Copper Chase at Sterling Ranch

PUD Site Plan

PUDSP 22-002

# V3\_PUD Plan.pdf Markup Summary 6-6-2023

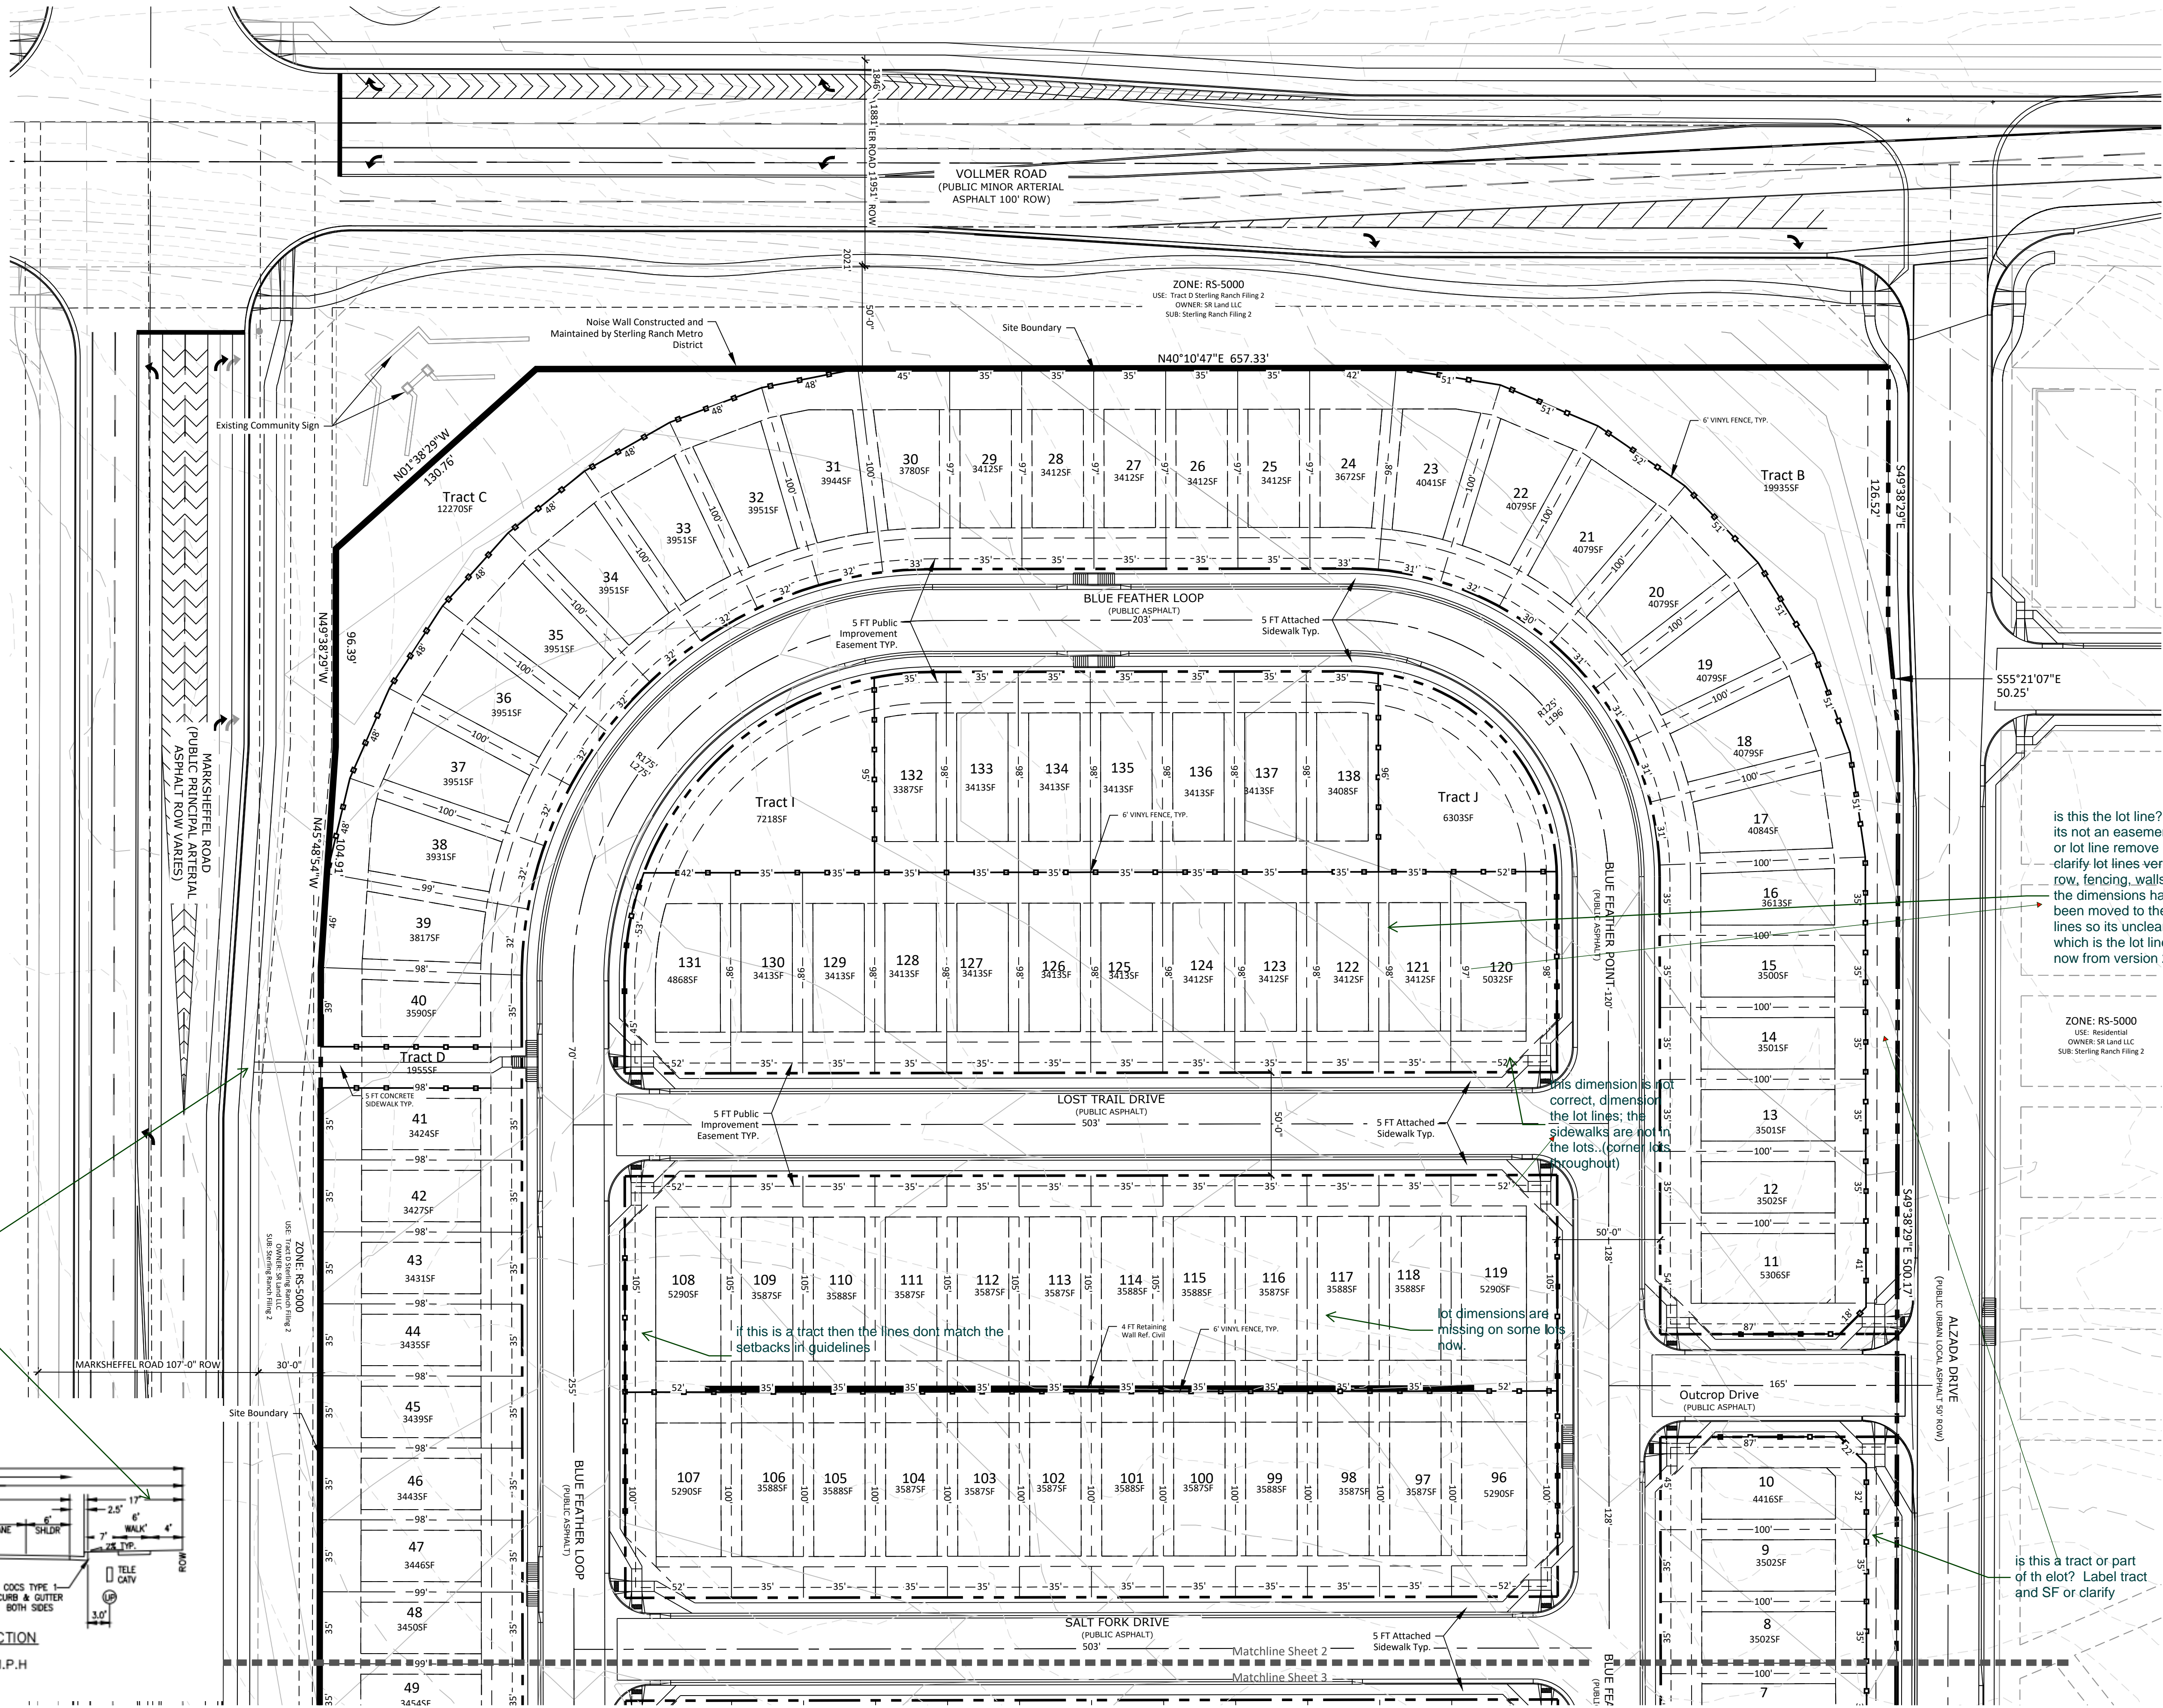
Label the elevations for proposed and existing contours.

asa general note lot lines are very hard to determine

verify there is not a trail adj to Marksheffel- final design was approved for Marksheffel, and i thought it had a pedestrian way.

walkway per crosssection

is this the lot line? if its not an easement or lot line remove it to clarify lot lines verses row, fencing, walls- the dimensions have been moved to these lines so its unclear which is the lot line now from version 2-i

This dimension is not correct, dimension the lot lines, the sidewalks are not in the lots. (corner lots throughout)

if this is a tract then the lines dont match the setbacks in guidelines

lot dimensions are missing on some lots

is this a tract or part of th elot? Label tract and SF or clarify

PUD Site Plan

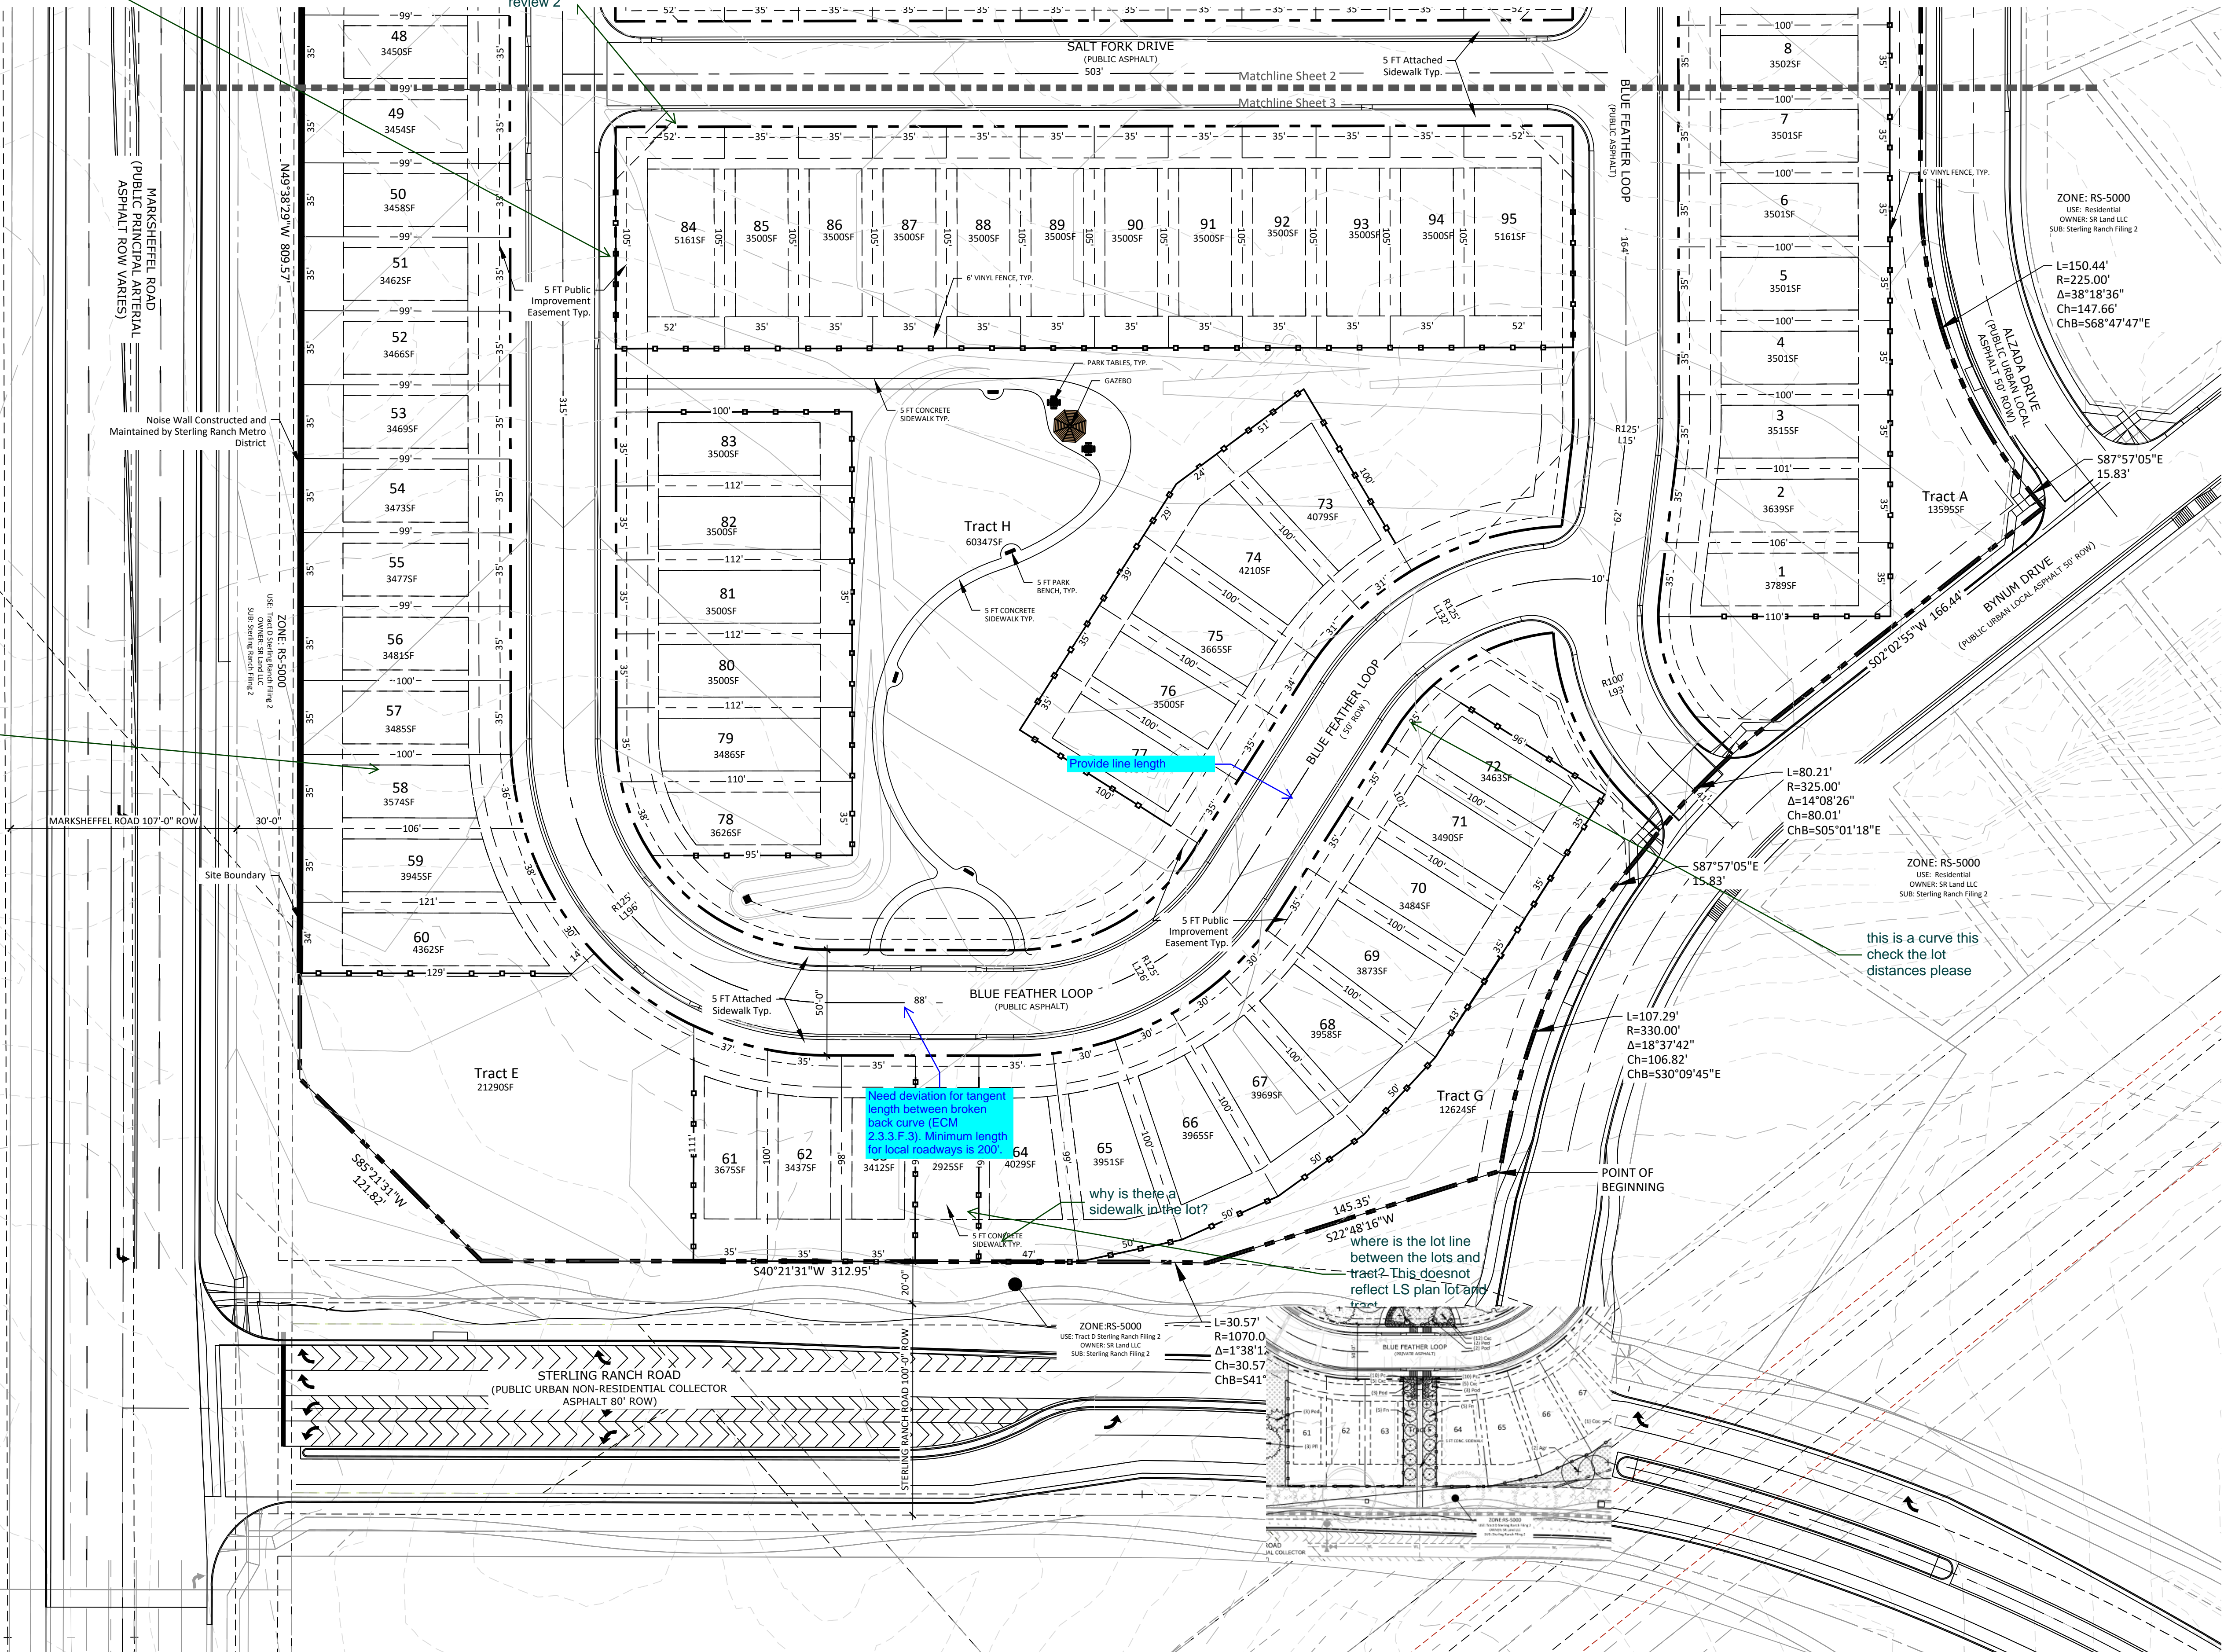
attached sidewalk disappeared from review 2

ped ramps at corners disappeared from review 2

what is this line?

### PRELIMINARY UTILITIES

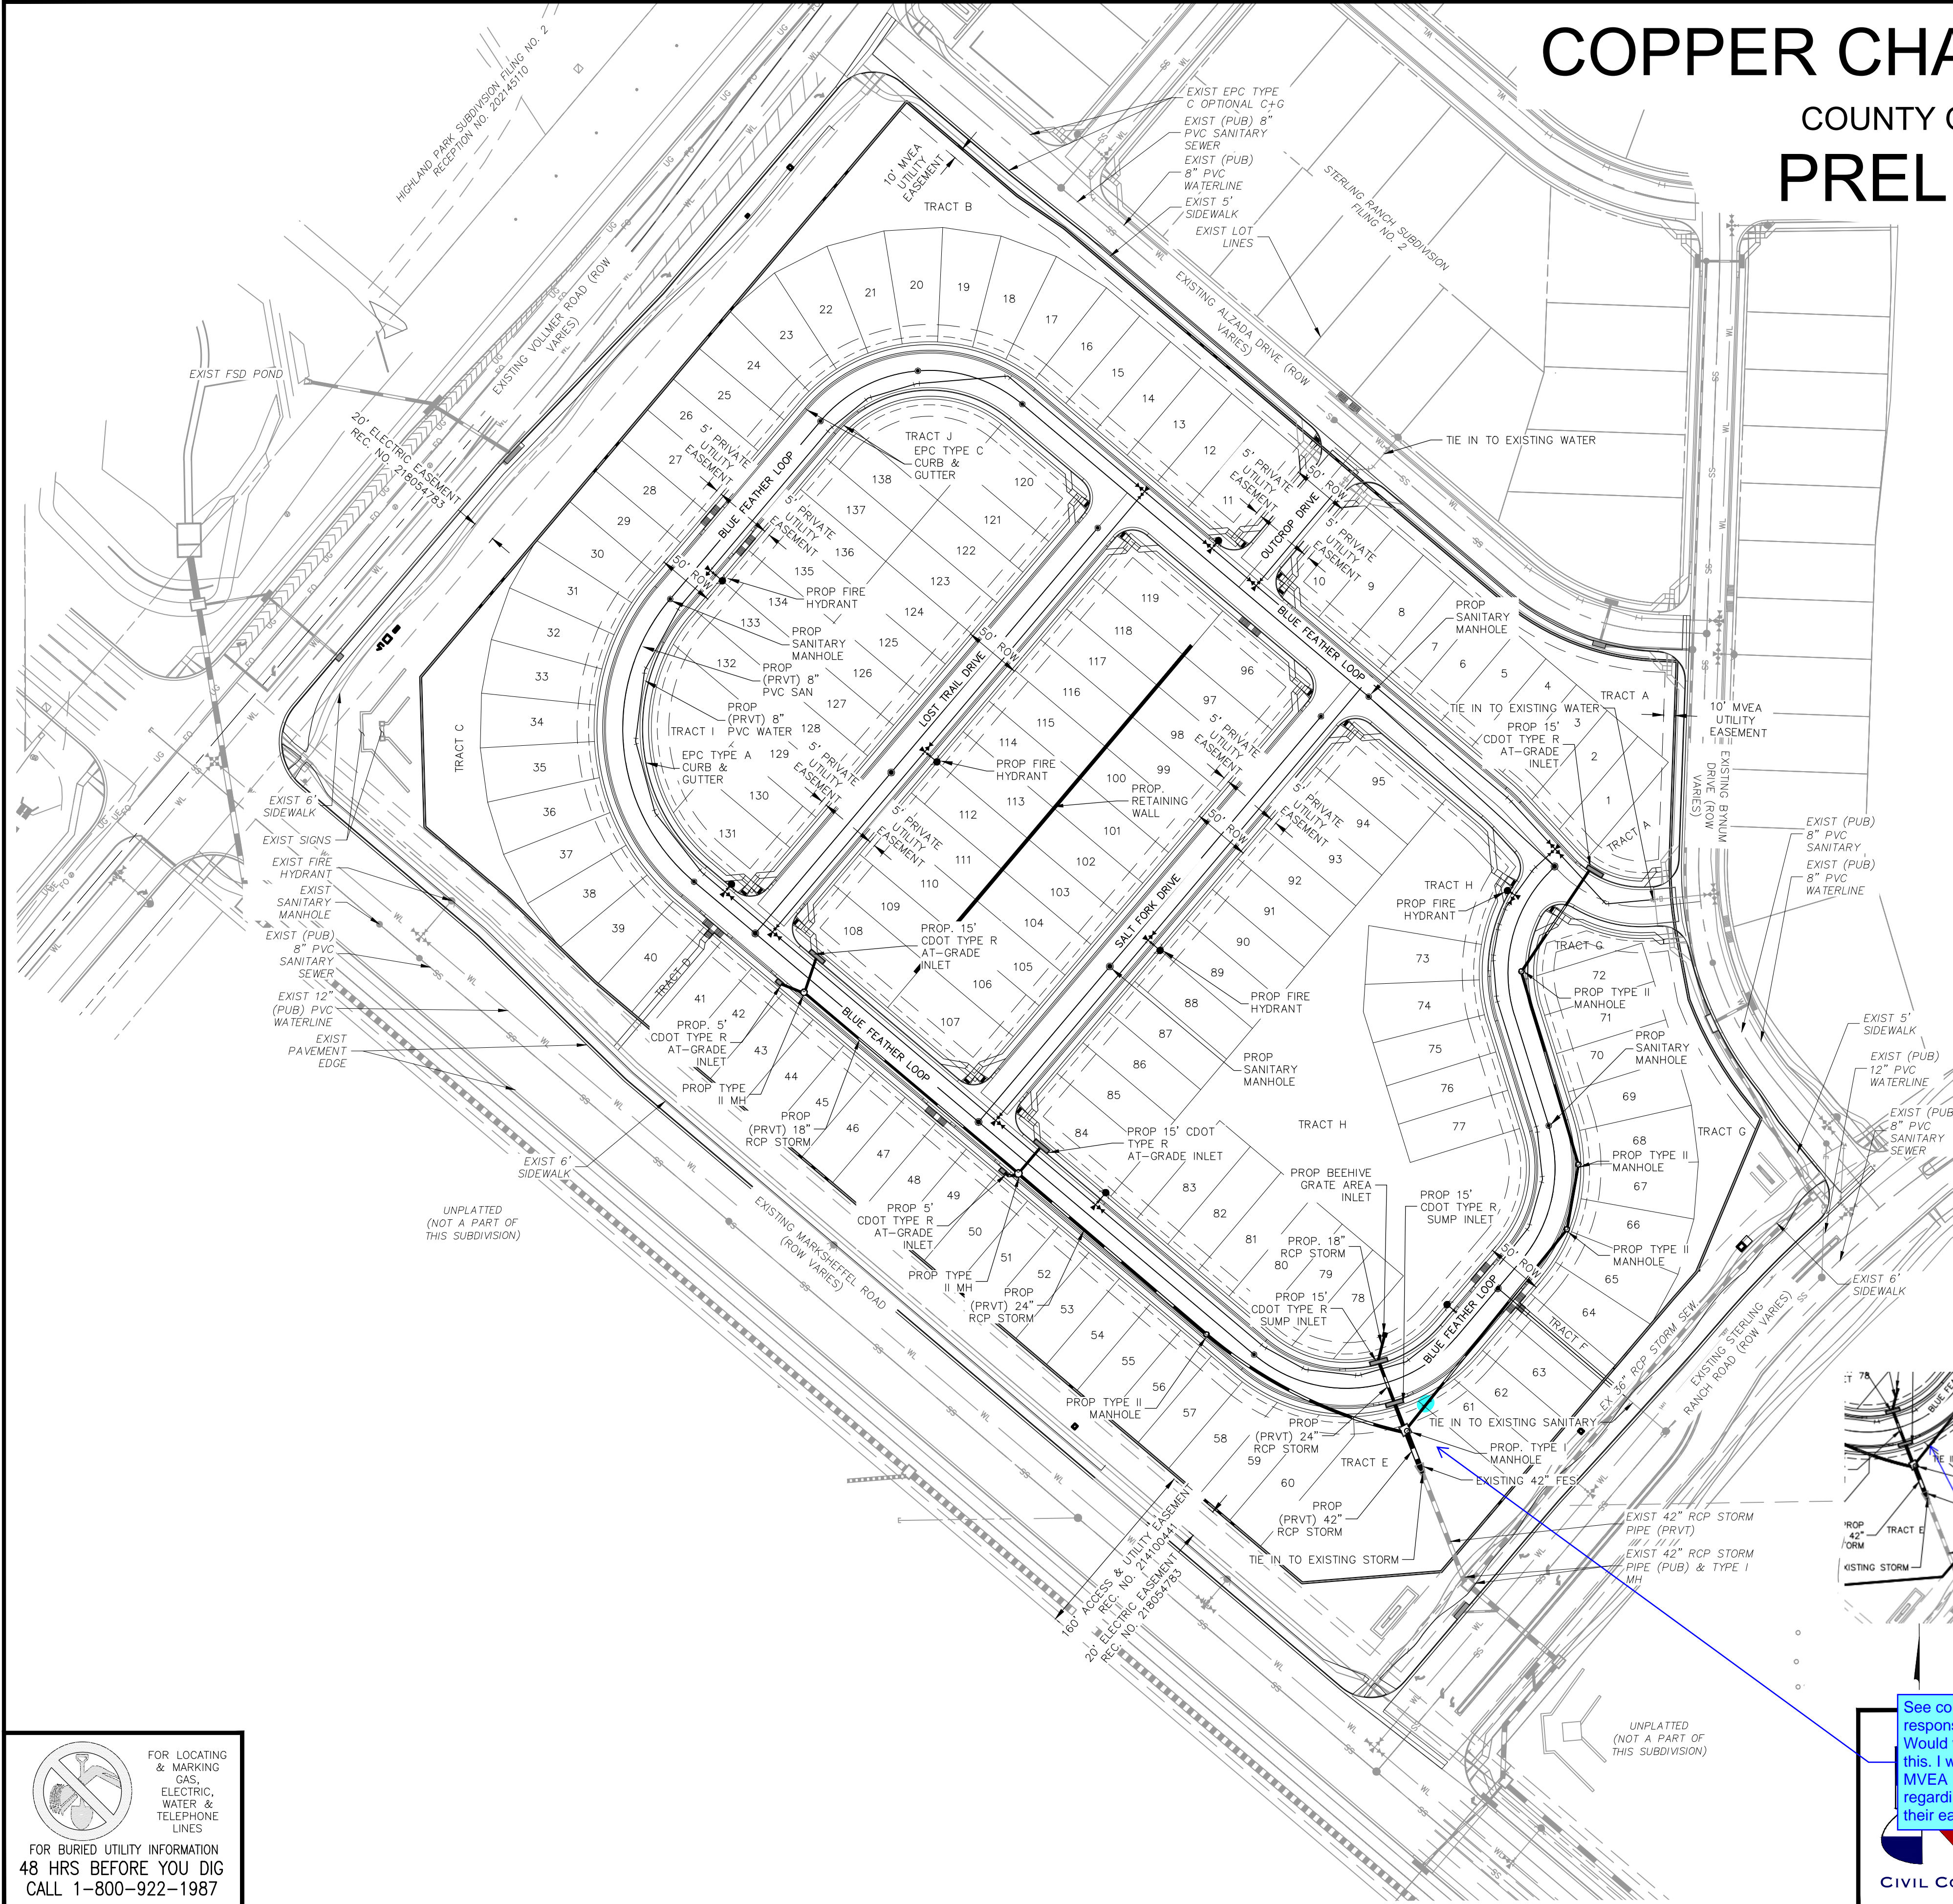
Update cross section details. Revised TIS and PUD plan show roads being public now.

See comment response from MS. Would we resolve this. I will look for MVEA responses regarding cutting into their easements.
